PROJECT: Summerlin Village 24 - Parcel 1

CITY OF LAS VEGAS		DATE:
INTER-OFFICE MEMORANDUM		October 30, 2018
TO: Land Development Services Department of Building & Safety		FROM: Albert Sung, P.E. Flood Control Project Engineer Department of Public Works
SUBJECT:	Drainage Study for:	COPIES TO:
	Summerlin Village 24 - Parcel I	GCW Engineers/Surveyors
Cross Streets:	SWC of Crossbridge Drive & Suncreek Drive	Pardee Homes
File Number:	F:\Depot\DSMemos\DS5023C.doc	Bart Anderson, P.E., DevCo
Parcel Number:	137-33-810-003	
Zoning Action:	TMP-73319	
FEMA Flood Zone	YES NO X	
Proposed Storm Drain	YES X NO

**2nd RESPONSE TO COMMENTS FOR THE
TECHNICAL DRAINAGE STUDY
FOR
Summerlin Village 24-Parcel I**

Re: 2nd Response to City of Las Vegas Comments on the Technical Drainage Study for Summerlin Village 24-Parcel I (DS-5023A)

CUT-OFF WALL

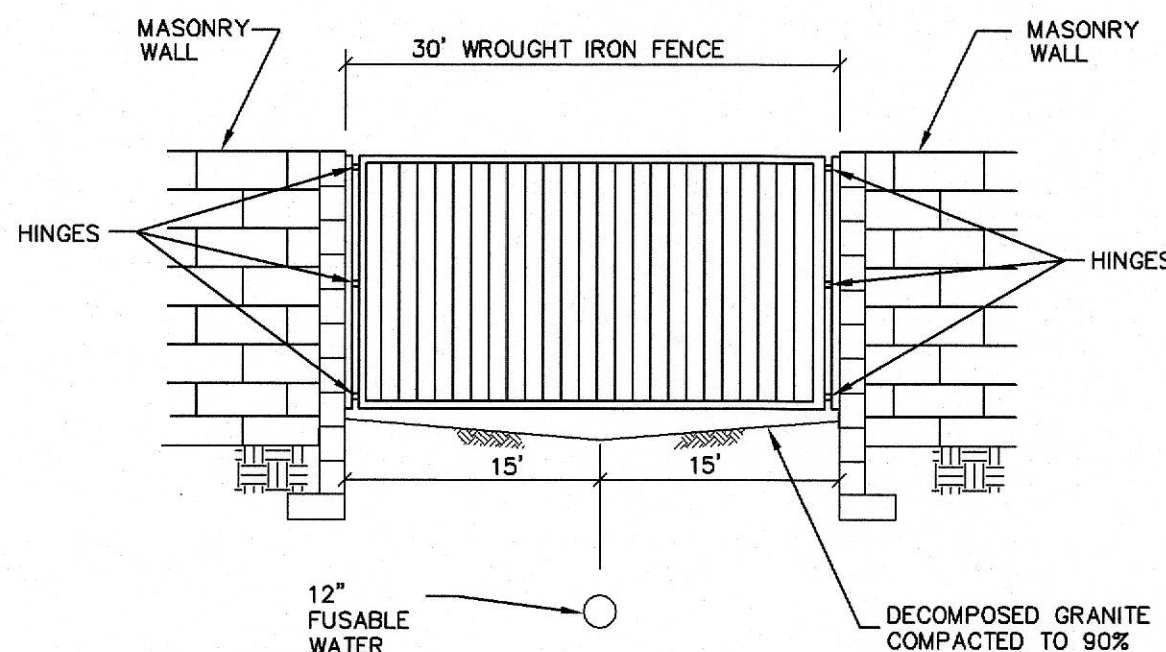
Detail Section M/DT-2: Provide a 3'-cutoff wall below the footing of the community retaining wall.

Per a discussion with Albert Sung, it was determined that the existing cutoff wall provided by the COS-3 Wash is sufficient to protect the southern lots from the flows in the Wash. The location of greatest worry were lots 32 and 33 since they have a FF elevation below the WSE. It was determined that the cutoff wall depth provided south of lots 32 and 33 will provide adequate protection from flow in the COS-3 wash. The depth of the existing cutoff wall varies from 6-8' and has been designed to provide protection that exceeds the 100-year scour throughout the entire wash. Pertinent reference material from the COS-3 Wash study including the scour depth calculations, typical sections, plans, and profiles are included in the appendix. The typical sections provided in the V24 Parcel I plans have also been updated to better reflect this cutoff wall.
